Traffic Engineering Letter

To	Independent Living Australia Pty Ltd	Date	10 July 2026
Prepared by	Bradley Fuller, Modus Senior Traffic Engineer	Approved by	Harj Singh, Modus Executive Director (RPEQ 22364)
Location	200 Bradman Street, Sunnybank		
Subject	Proposed Development - Traffic Engineering Letter		
Status	Final	Attachments	Appendix A: BCC Information Request Appendix B: Revised Development Plans Appendix C: Car Parking Surveys

Information Request Item 3

Figure 1 Minimum Queueing Provisions to First Visitor Space

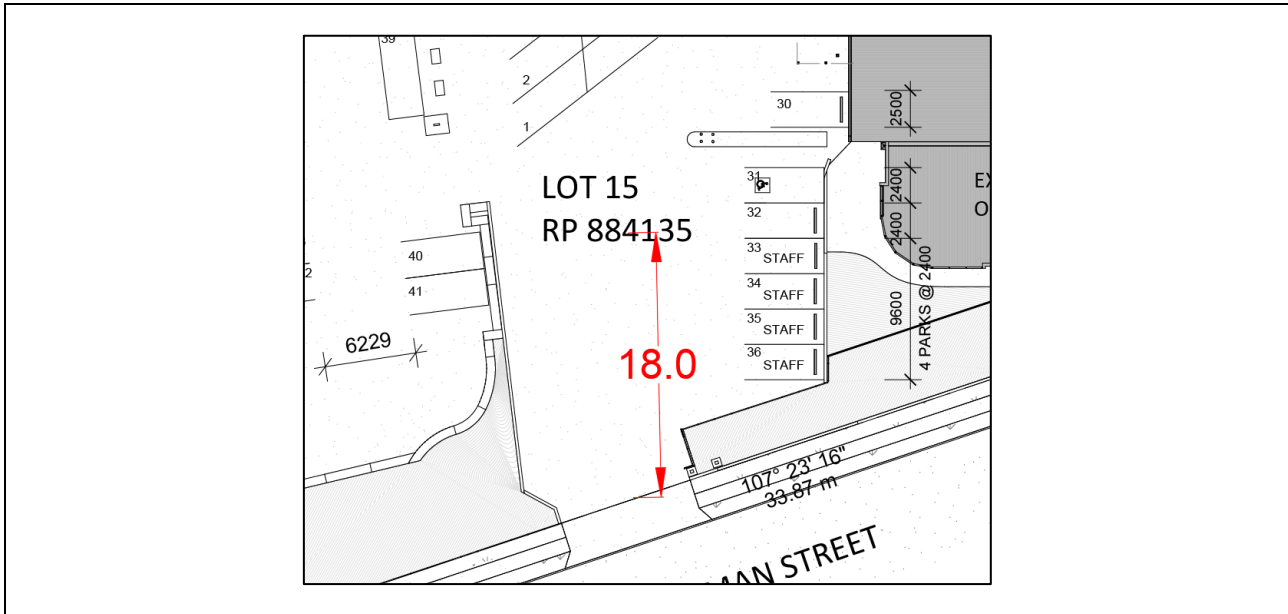
a. Provide a queuing assessment demonstrating that the 36 dedicated car parking spaces and the permeable parking area can accommodate peak drop-off and pickup demand, including early arrivals, without queuing extending to or impacting the external road network. The assessment is to be supported by peak parking utilisation / accumulation data from the existing operation, including arrival patterns and dwell times during class changeover periods.

The revised development plans, provided at **Appendix B**, demonstrate a minimum queuing provision of 18.0m (equivalent to three vehicle lengths) from the property boundary to the first visitor car parking space.

In accordance with the BCC TAPS PSP, a minimum queueing of 18.0m (equivalent to three vehicle lengths) is required when a car parking accommodate between 51 to 75 parking spaces.

Provided that the peak car parking demand is 71 car parking spaces, in addition to staff vehicle movements being limited during peak hour periods, the queueing provisions are considered acceptable.

Noting that the development will cater for one (1) inbound vehicle every 23 seconds, practically a vehicle will be able to travel through the site and clear the 18.0m queueing requirement within 23 seconds before the next vehicle enters the site.

As such, the proposed queueing provisions are considered acceptable and the development will not have any queueing impacts onto the external road network.

1 SITE PLAN - NEW WORKS

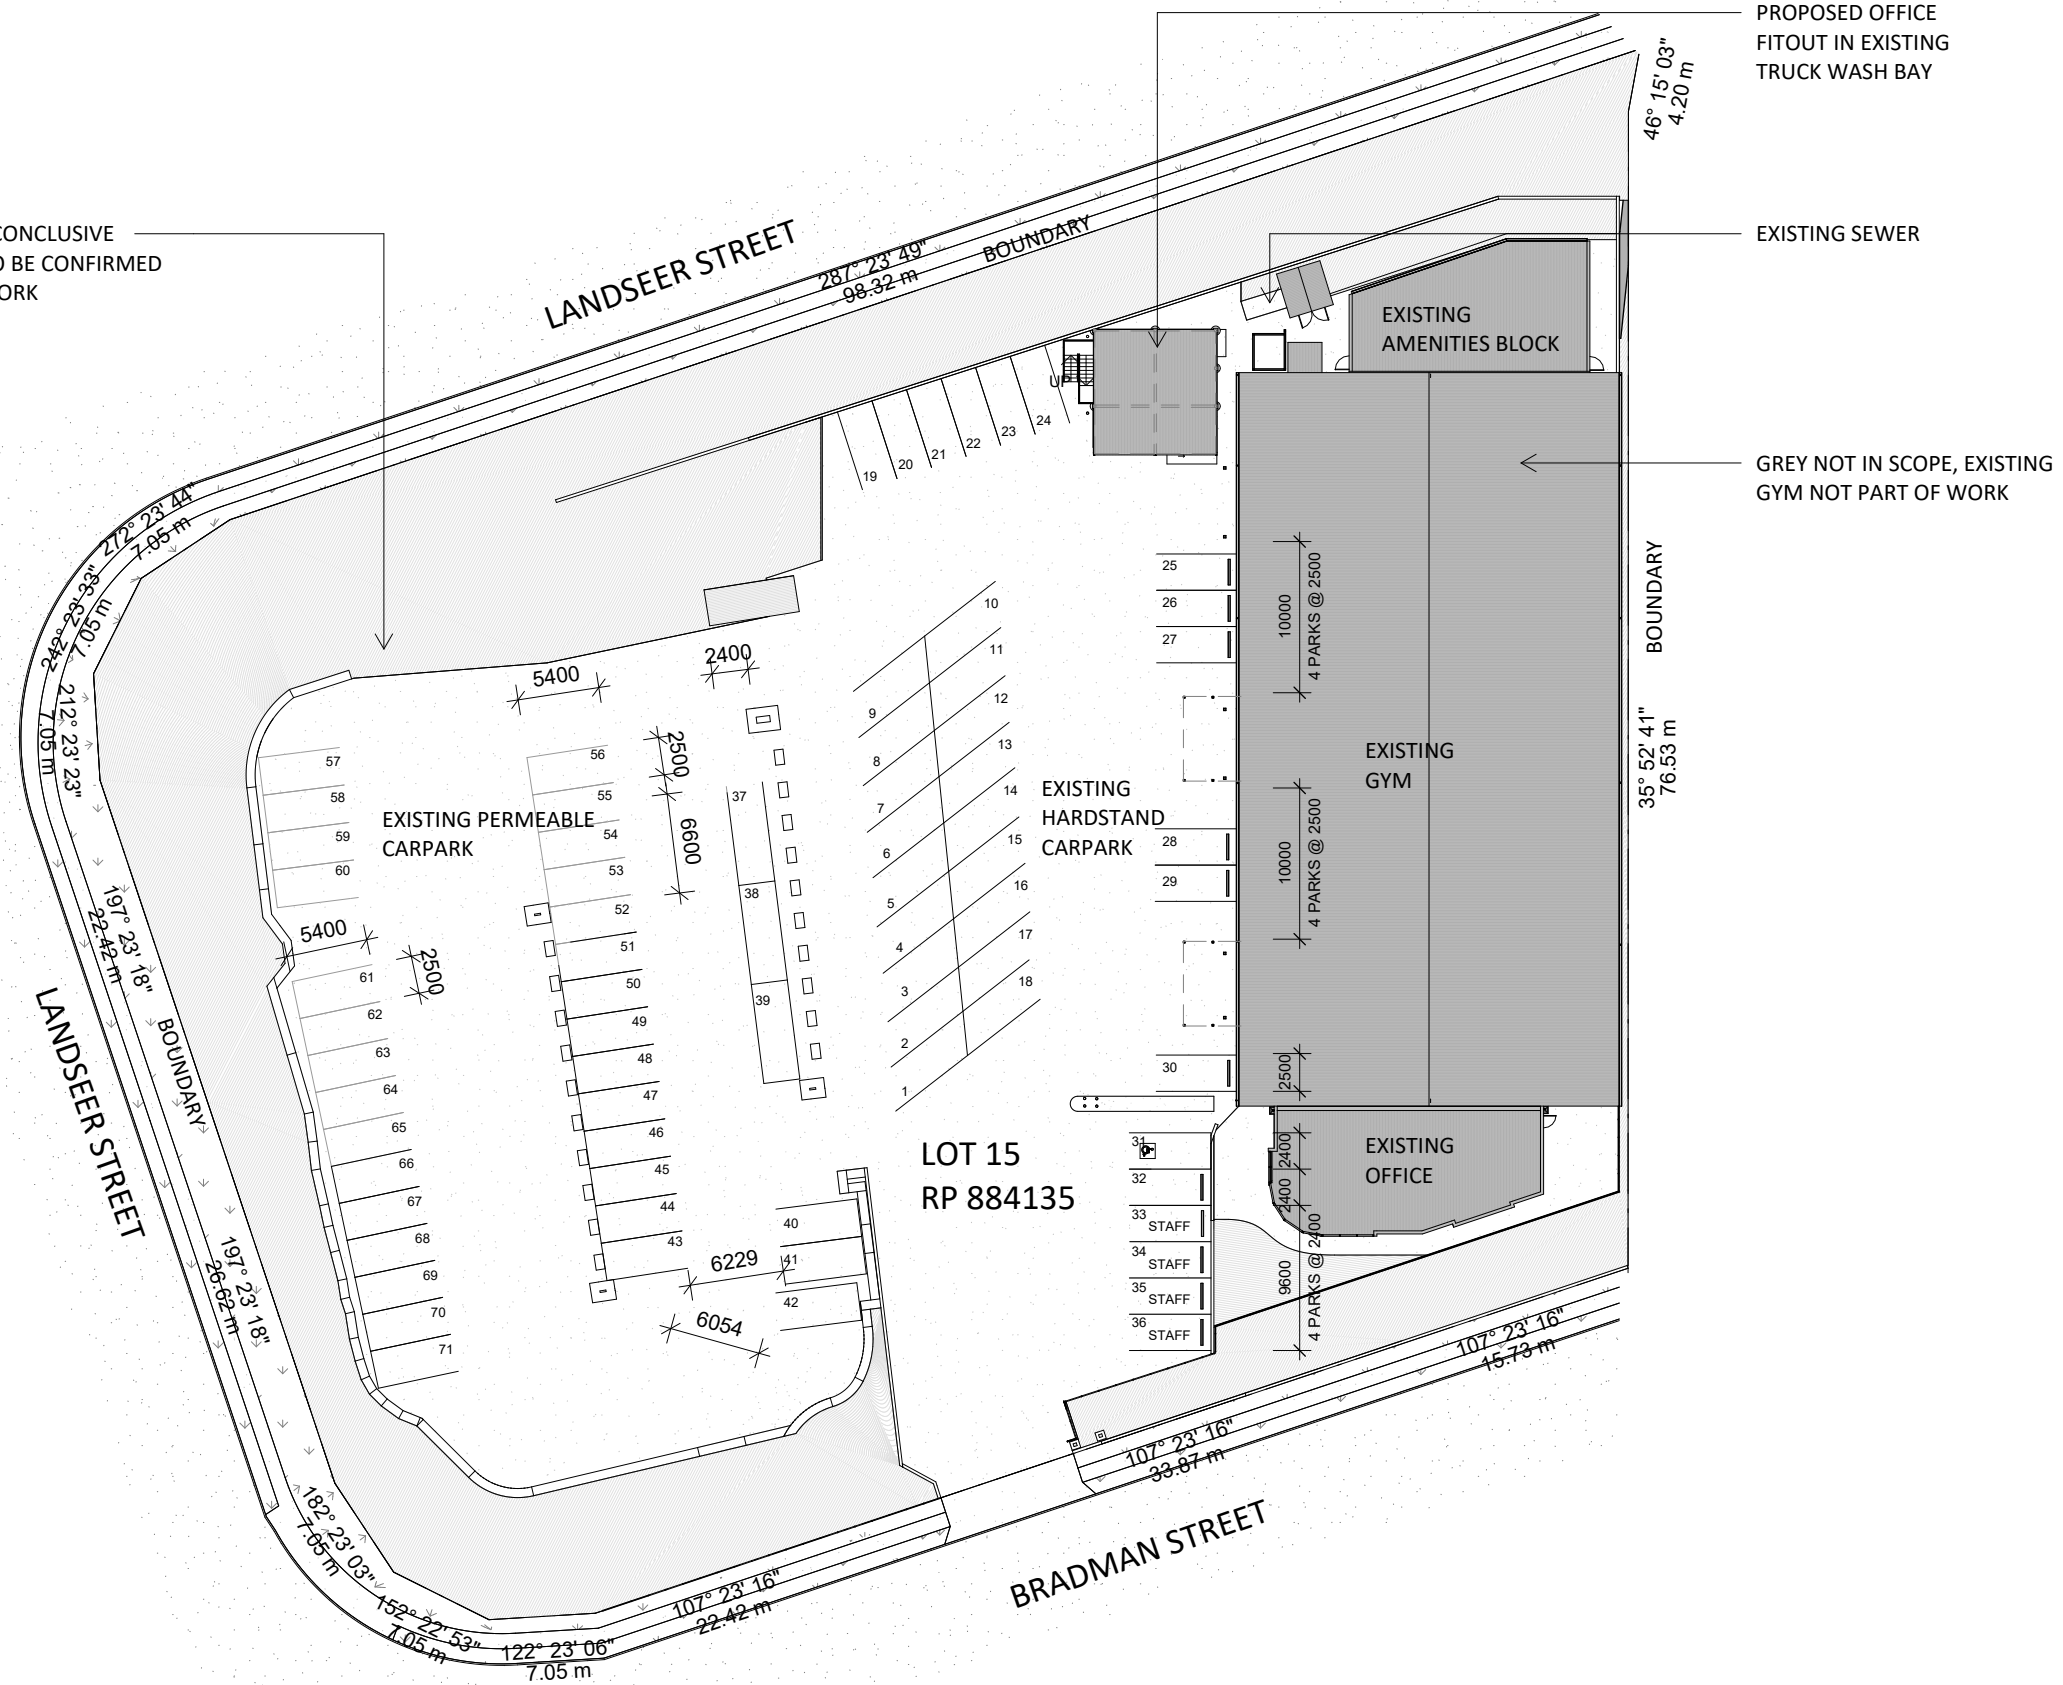
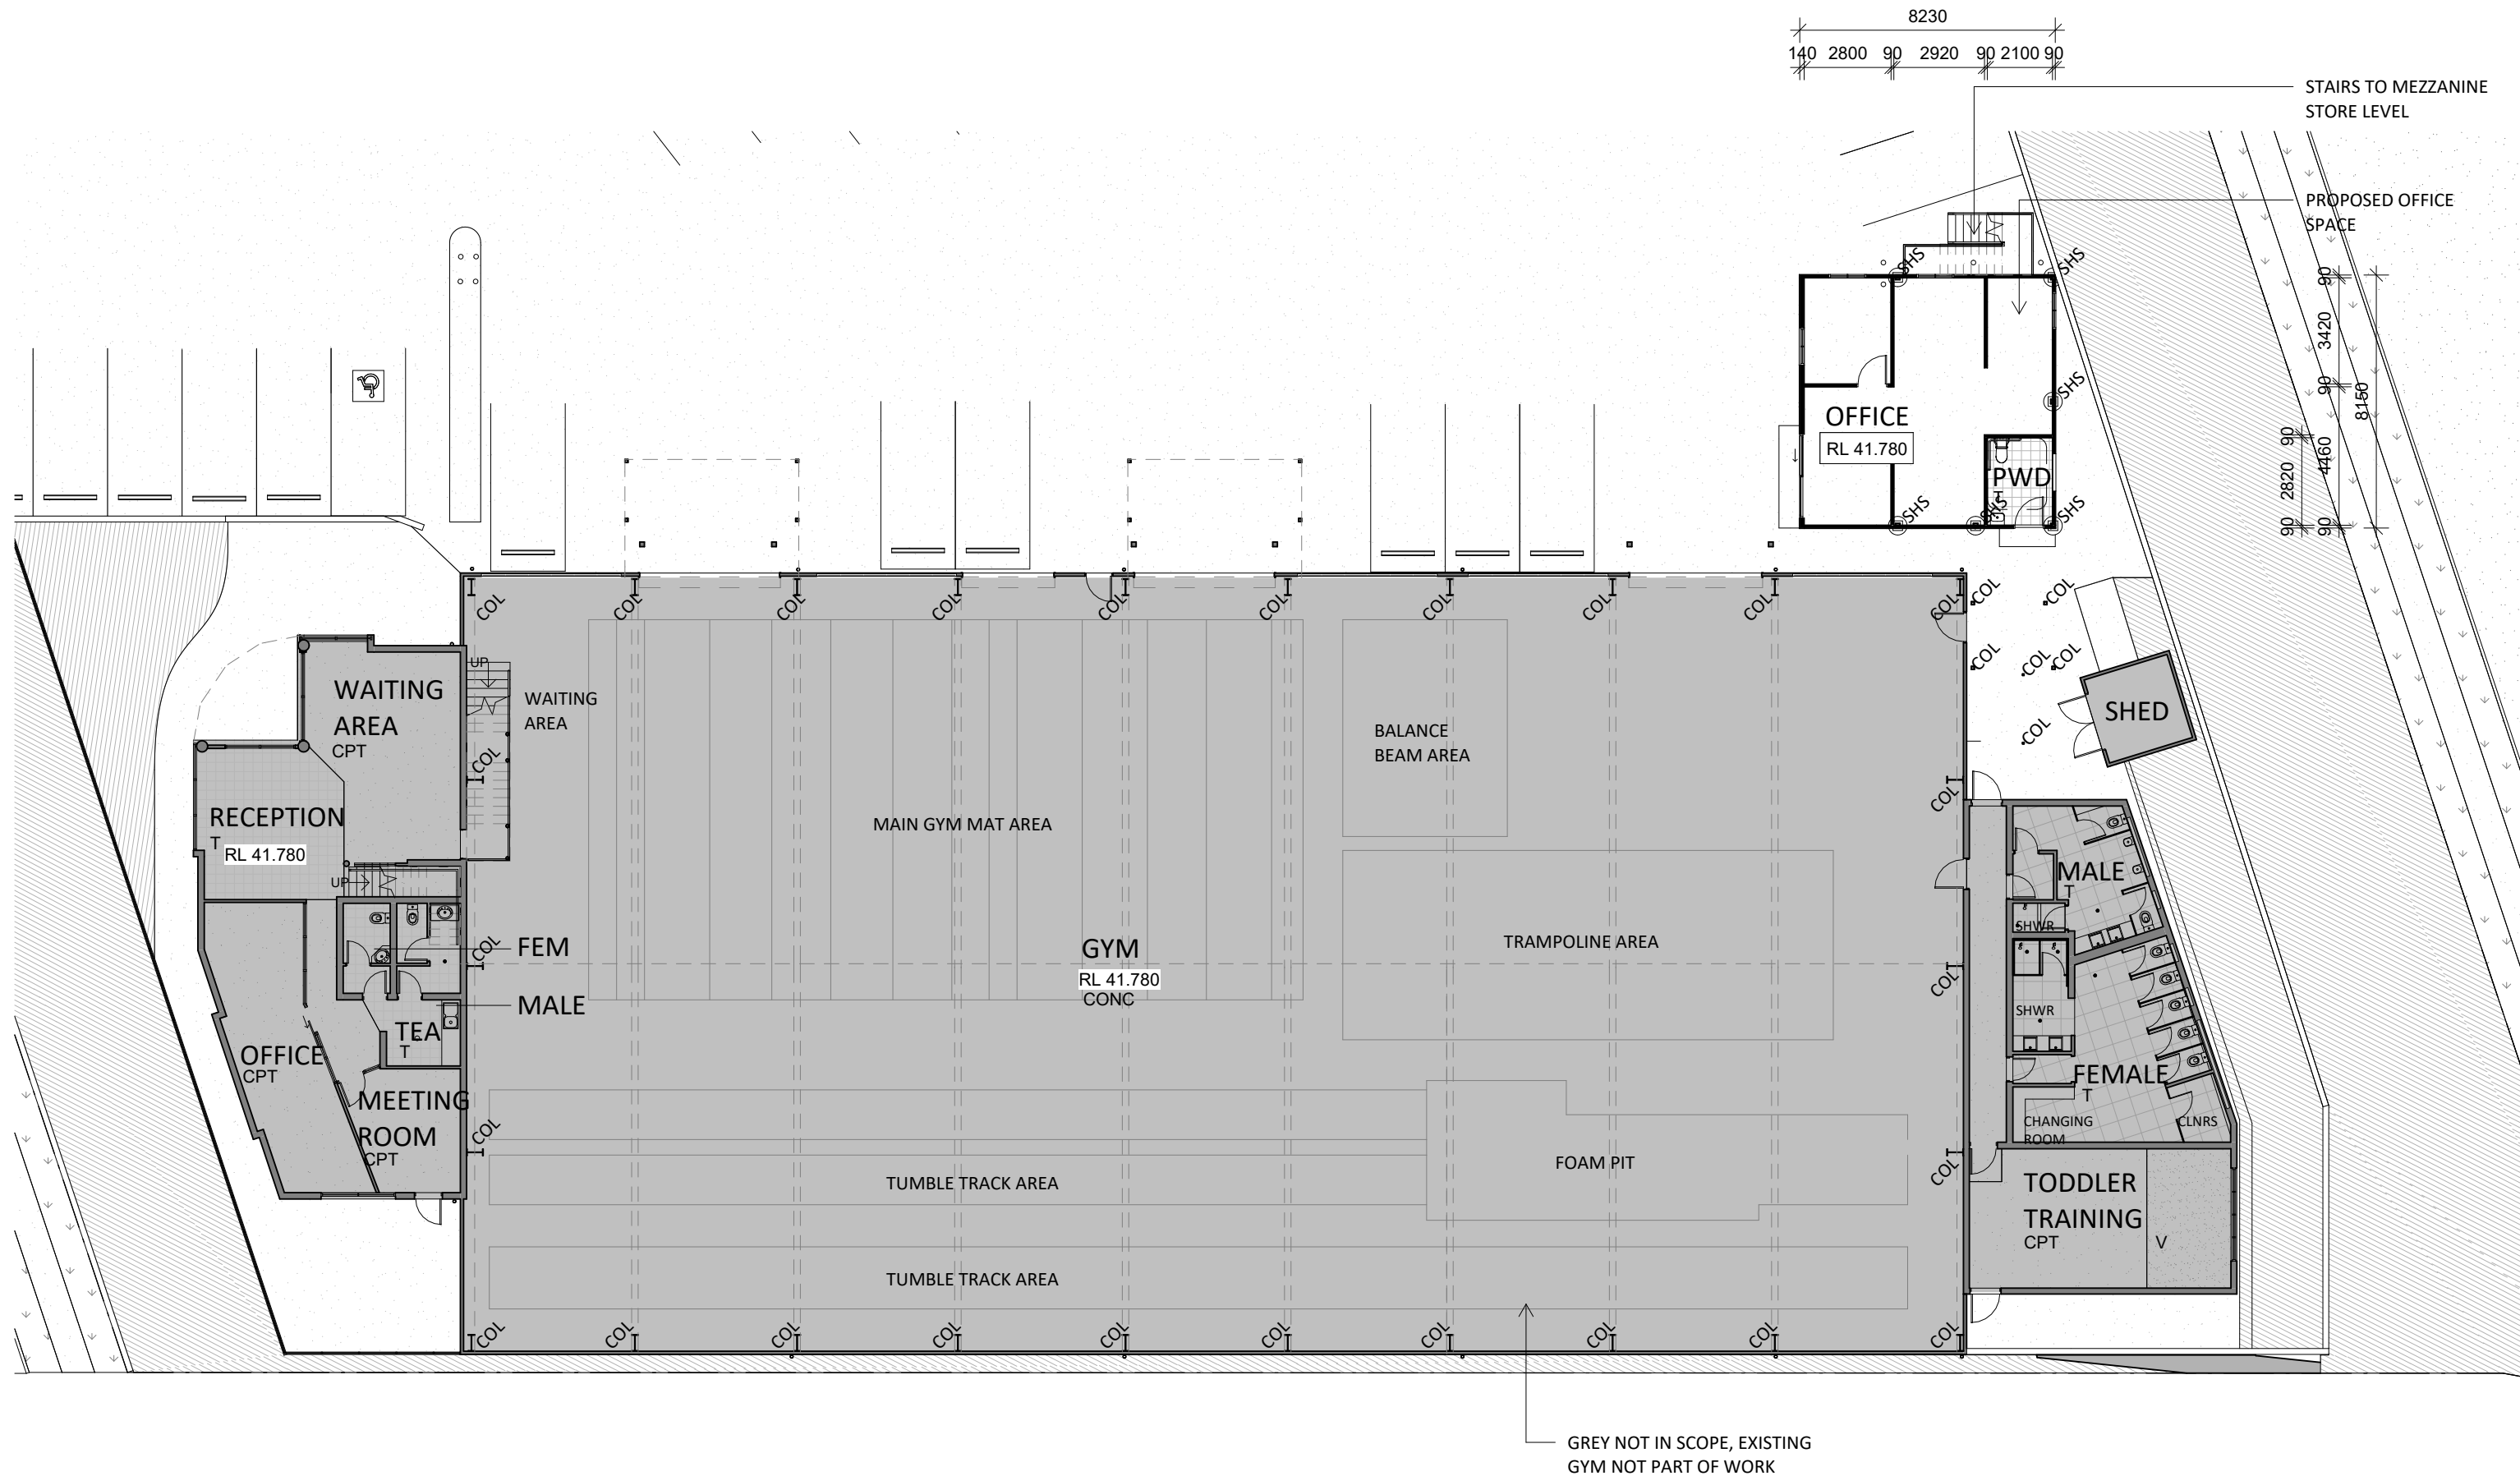
a. Provide a detailed car parking layout plan which clearly shows all line marking, numbered car parking spaces for ease of reference, and all relevant dimensions, including bay widths, lengths, aisle widths, and turning areas.

Therefore, the revised development plans, provided at **Appendix B**, demonstrate the dedicated line marking to cater for 71 car parking spaces on-site, of which 35 of these spaces will be accommodated within the existing permeable car park.

Furthermore, the car parking layout of the new 35 car parking spaces ensures compliance with Australian Standards 2890.1.

Modus recommends that any new car parking spaces accommodate suitable surface conditions to comfortably cater for vehicle movements to, within and from the existing permeable car park.
